Drainage Report

**For the Dos Lagos Lot 'C'
Parcel Number: 0419106030
4202 5th St SE
Puyallup, Washington**

April 2021

**Revised August 2023
Job No: 12896**

Lot C Historical vs Developed Calculation For MR7

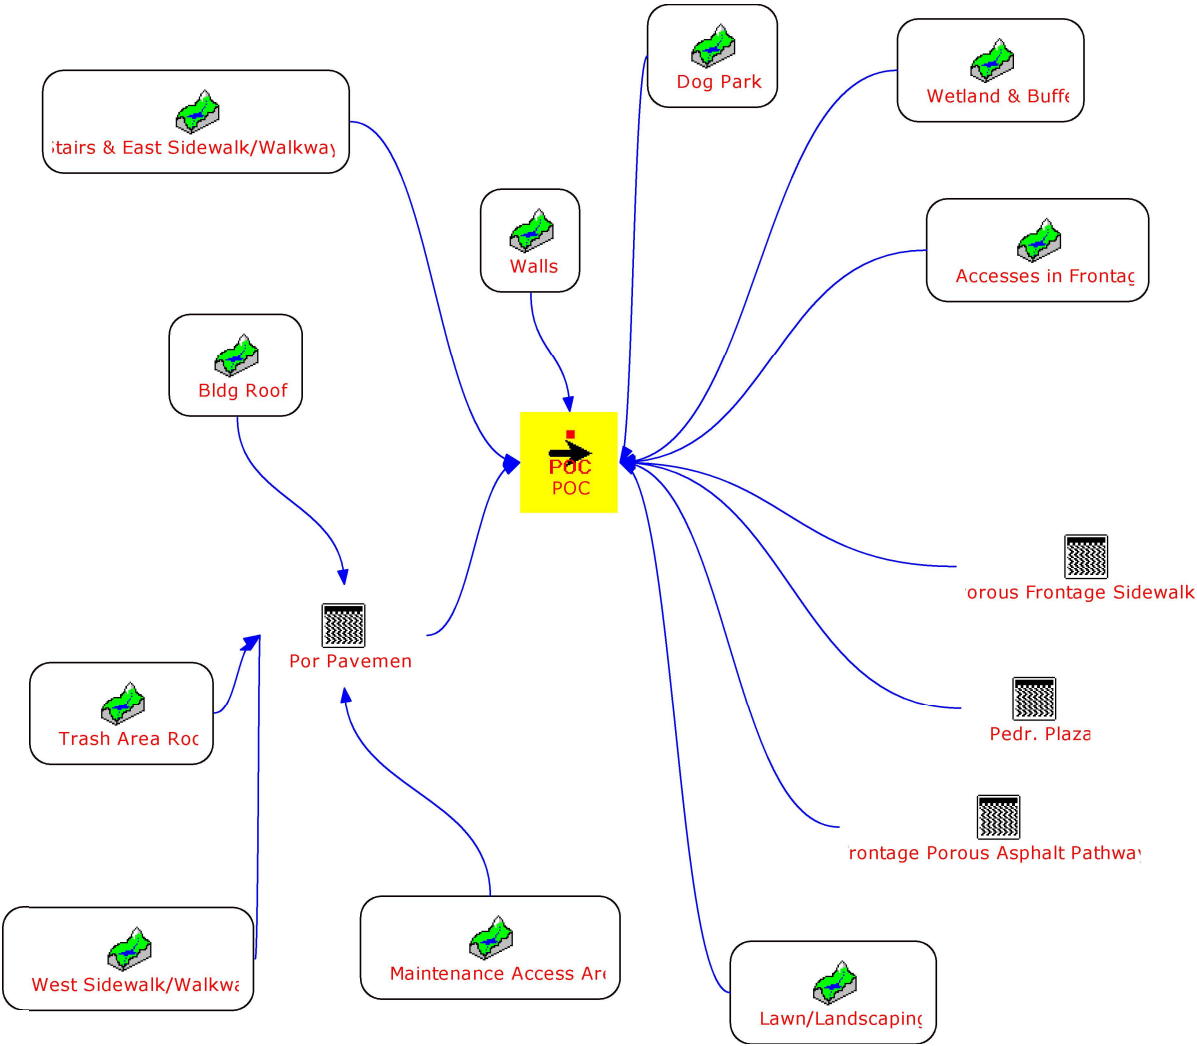
See comments under MR5 and MR7.
[Storm Report-Lot C; Pg 20 of 95]
